ARGENTINEAN NATIONAL REPORT FOR THE CONVENTION ON NUCLEAR SAFETY ANSWERS TO QUESTIONS OR COMMENTS - 2023

This Report is produced by the Autoridad Regulatoria Nuclear (Nuclear Regulatory Authority) on behalf of Argentina.

ARGENTINEAN NATIONAL REPORT FOR THE CONVENTION ON NUCLEAR SAFETY Ninth Report - **ANSWERS TO QUESTIONS OR COMMENTS**

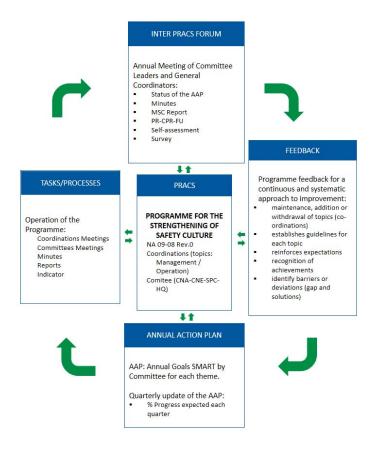
Can you please provide some information on the flow of documents associated with PRACS? Who receives the results of such an assessment? Are there any comments and feedback to the

Below you will find the flow process of PRACS that includes the documentation:

The results of the programme are received by:

- Plants Committees (Atucha and Embalse NPPs):
- managers and deputy managers
- Corporative Committee: managers and deputy managers
- Plant Services Committee: managers and deputy managers

Coordinators of each topic: personnel designated responsible for each topic. Feedback and comments are taken into account in the Inter PRACS Forum to define the Annual Goals for the Annual Action Plans.
